**Economic and Social
Council**

TRANS/WP.29/GRPE/35
4 March 1998

Working Party on the Construction of Vehicles

REPORT OF THE MEETING OF EXPERTS ON POLLUTION AND ENERGY
ON ITS THIRTY-FIFTH SESSION
(13 - 16 January 1998)

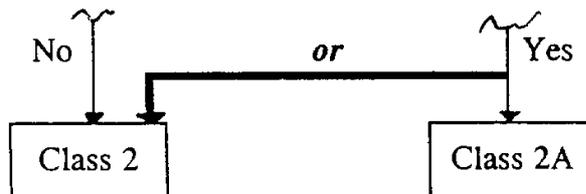
Paragraph 2, Figure 1, in the second lozenge amend the words "Safety valve" to
read "Safety valves"; in addition, insert a following liaison between the
rectangles of "Class 2" and "Class 2A":
